**TOWN AND COUNTRY PLANNING ACT 1990
APPEAL UNDER SECTION 78**

Site Address: 55 Vastern Road, Reading, RG1 8BU

Planning Inspectorate Reference No.: APP/E0345/W/21/3276463
Planning Reference No.: 200188

Statement of Case on Highway/Transport Matters

Figure 1

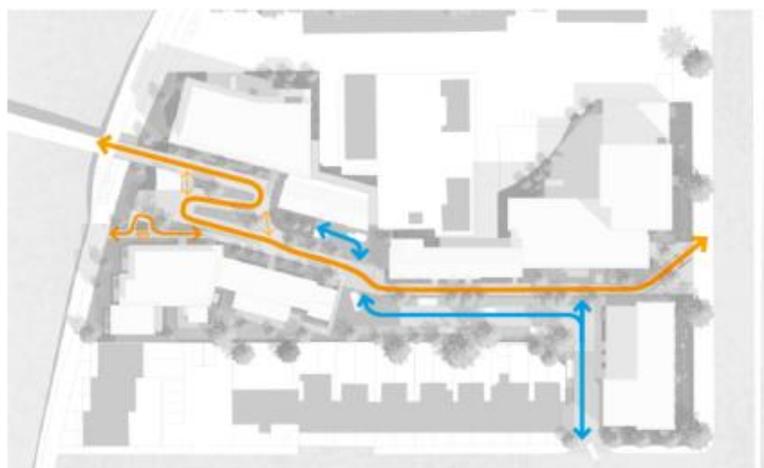
5.5.2 However at page 8 of the Berkeley Homes Strategic Shared Cycle Footway' booklet which can be found at Document 6.67 of the Appellant's submission, it is illustrated within the below diagram that the route between the application site and the Towpath is a pedestrian / cycle route. The text explains that the gradient of this route would be 1:21 (4.76%) or less.

5.5.3 Irrespective of the above the gradients specified on the detailed design drawings include gradients of between 1:14.5 and 1:15 which do not comply with Figures 2 or 3 taken from Local Transport Note 1/20, Cycle Infrastructure Design dated July 2020 and CD 195 Designing for cycle traffic respectively. These tables can be found at Paragraph 4.13.2 and 4.13.4 of this Statement. The gradient of the route therefore would not comply with the National Design Standards for a cycle route.

5.5.4 Given the proposed gradient the Appellant now stipulates in contradiction to Figure 1 above that the route to the Towpath is solely for the use of pedestrians and as such it is claimed that the gradients of 1:14.5 and 1:15 are acceptable. However, it should be stated that in relation to these gradients Section 3.2 of Department for Transport document Inclusive Mobility states the following:

5.5.7 Irrespective of the above the Highway Authority do not agree that this route should be pedestrian only as it will provide cycle access from the cycle route along Vastern Road to the Towpath along the River Thames. To the east of this point of access is National Cycle Network Route 5 and therefore this route would become the desire line between NCN Route 5 / the Towpath and the town centre, as such the route must be designed to accommodate cyclists.
